Access Compliance Report

Public Rights-of-Way

Intersection ID: 28883	Main Street: BALDWIN_HALL_DR	Cross Street: CAMPBELL_HALL_CT	Location: SW
ADA ID: 5873A585510F	Ramp Type: Perp	Initial Pass/Fail: Fail	Overall Compliance: No
Codes/Mitigation Info/Possible Solution		Field Measurements/Component Compliance	
Severity Score: 8.75

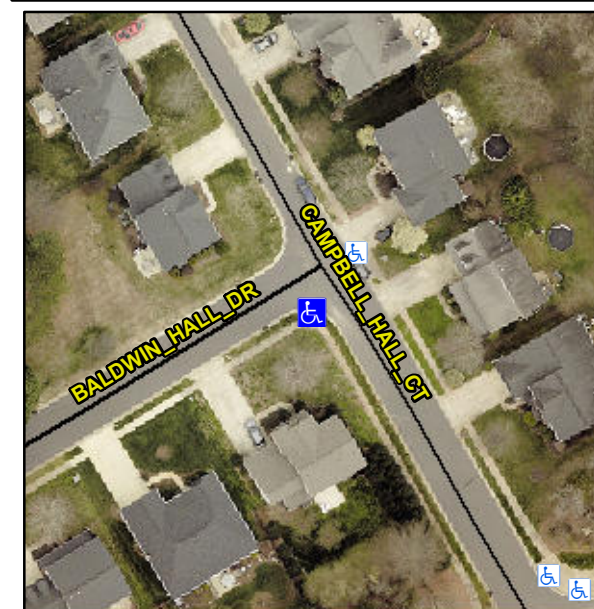
Not Found, R304.5.1

Compliance	Description	Data	Compliance	Description	Data
N/A	Ramp Length (in)	50.0	Yes	Ramp Slope (%)	5.2
No	Ramp Width (in)	37.0	Yes	Ramp XSlope (%)	0.7
N/A	Flare Type LT	N/A	N/A	Flare Type RT	N/A
N/A	Flare Slope LT (%)	N/A	N/A	Flare Slope RT (%)	N/A
N/A	Flare Traversable LT?	N/A	N/A	Flare Traversable RT?	N/A
N/A	Landing Length (in)	N/A	N/A	DWS Provided?	N/A
N/A	Landing Width (in)	N/A	N/A	DWS Contrast?	N/A
N/A	Landing Slope (%)	N/A	N/A	DWS Length (in)	N/A
N/A	Landing X Slope (%)	N/A	N/A	DWS Full Width?	N/A
N/A	Landing Curb? (Y/N)	N/A	N/A	DWS Offset (in)	N/A
N/A	Shared Landing?	N/A			
N/A	Gutter Ponding?	N/A	N/A	Gutter Slope (%)	N/A
N/A	Gutter Lip Ht (in)	N/A	N/A	Gutter X Slope (%)	N/A
N/A	Painted X Walk1?	No	N/A	Painted X Walk2?	N/A
	X Walk 1 Direction	To NE		X Walk 2 Direction	N/A
N/A	X Walk 1 Width (in)	N/A	N/A	X Walk 2 Width (in)	N/A
	X Walk 1 Slope (%)	0.2		X Walk 2 Slope (%)	N/A
	X Walk 1 X Slope (%)	0.2		X Walk 2 X Slope (%)	N/A

Remove & Replace Entire Ramp.
